North Roseville Specific Plan Phase II

Final Subsequent Environmental Impact Report
SCH #98112063

May 1999

Figure 2-1
"T" Intersection
Alternative Alignment Option

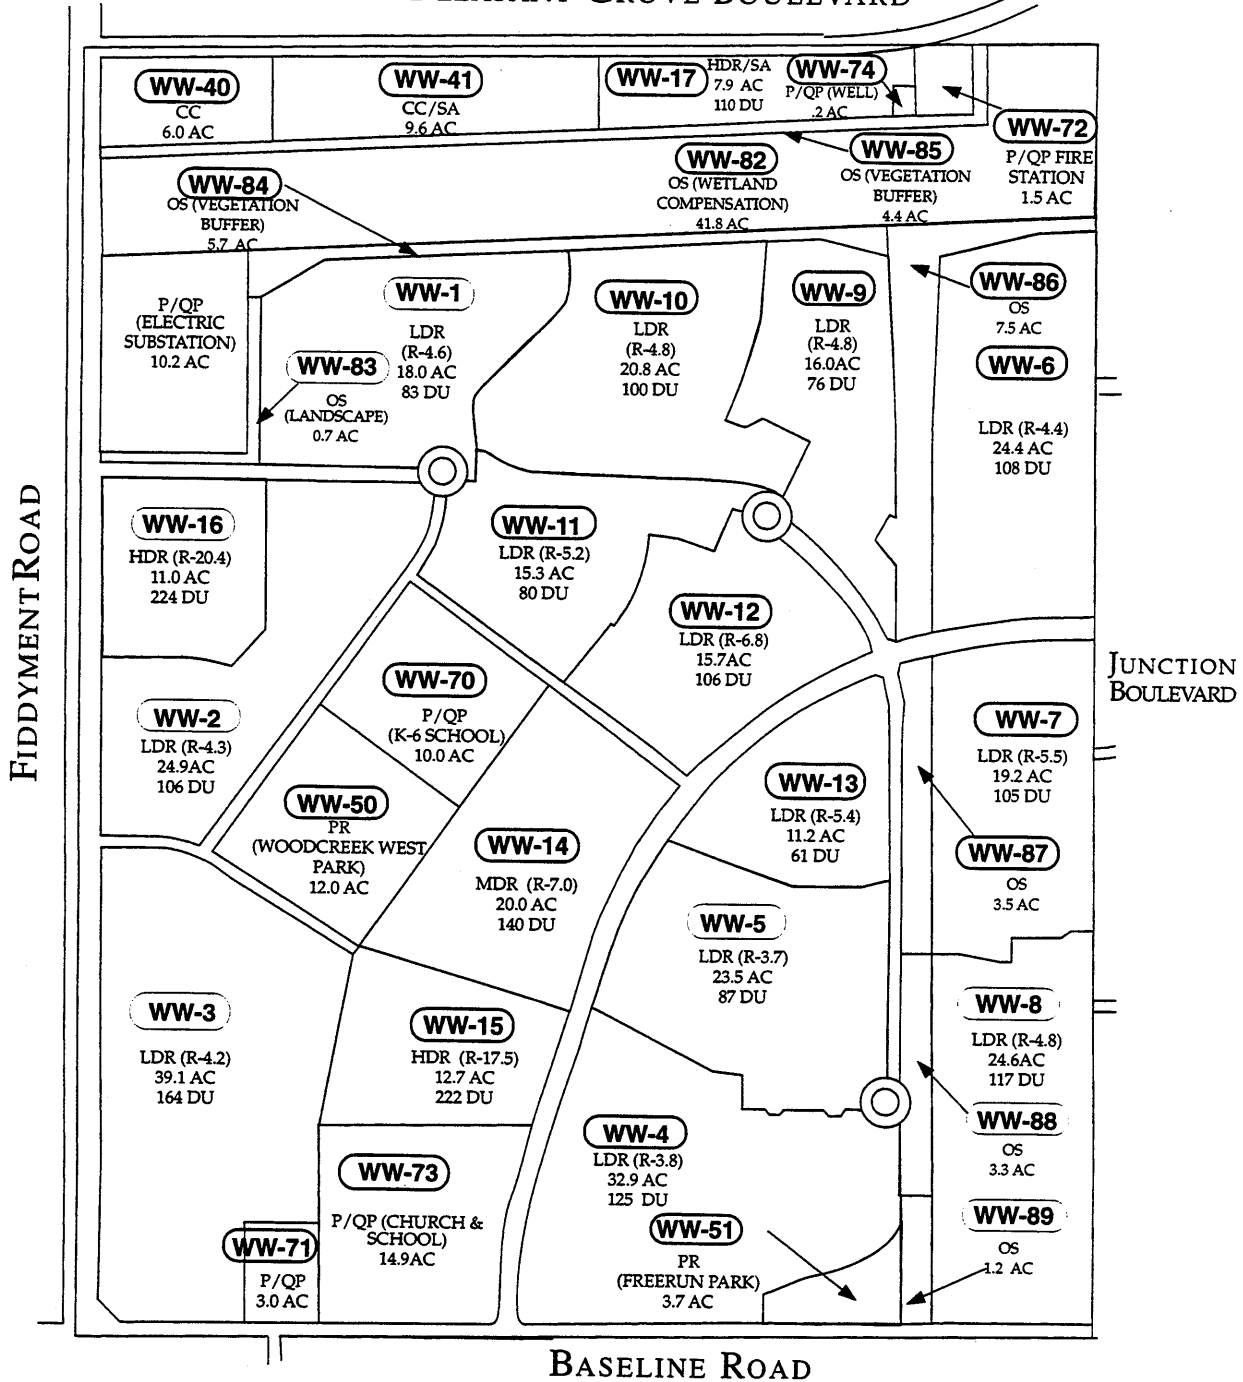
An option of a "T" intersection of Junction Boulevard into Baseline Road is included in the Specific Plan. Under that option the changes include:

These changes are illustrated on the "T" Intersection Alternative Alignment Option Figure 2-1 and Land Use Table 2-1.

Under this option there would be no change in the number of residential units included under the proposed project. The only changes would be a slight reduction in land set aside for road right-of-way and a slight reduction in acreage for the parcel dedicated for the school administration offices resulting in a slight increase in acreage for low density residential. These changes would not result in any changes in the environmental analysis, including the traffic analysis, prepared for the proposed project.

Figure 1 - Noise Barrier Reflection Characteristics - not to scale, for illustration only.

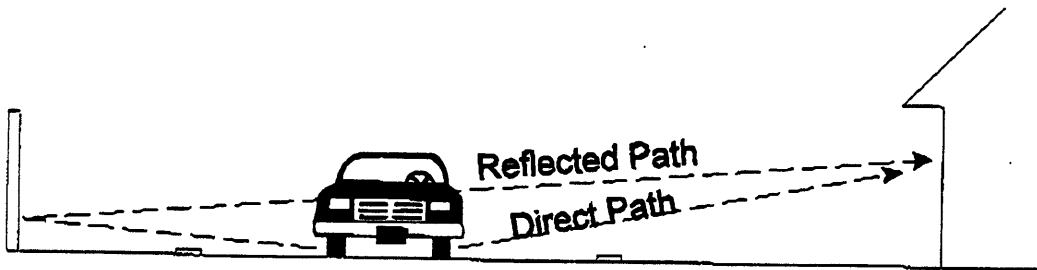
COMMENT LETTER 1: Arthur G. Baird**Response to Comment 1-1:**

Figure 1 is a simple illustration of the sound travel paths associated with noise barrier reflections. In theory, if 100 percent of the incident traffic noise were reflected perfectly off of the proposed noise barrier, without being absorbed or diffused, the total traffic noise level increase at the receiver would be approximately 1-2 dB higher than would be received at the nearest residence if the noise barrier were not constructed. The 1-2 dB increase is due to the fact that the reflected sound must travel farther to reach the nearest receiver in the Bianchi Estates development than the direct sound, as generally illustrated by Figure 1.

In practice, a perfect 100 percent sound reflection would not occur due to partial absorption and diffraction of sound which occurs at the surface of the barrier. Therefore, an increase of approximately 1 dB or less at the residences in question would be expected due to barrier reflection. Because a 3 dB change in similar noise sources is typically required before a change is perceived, the increase in traffic noise resulting from reflections off of the proposed Baseline Road noise barrier may very well be imperceptible. Variations in topography and landscaping would further reduce the amount of reflected sound, which would be absorbed or diffused.
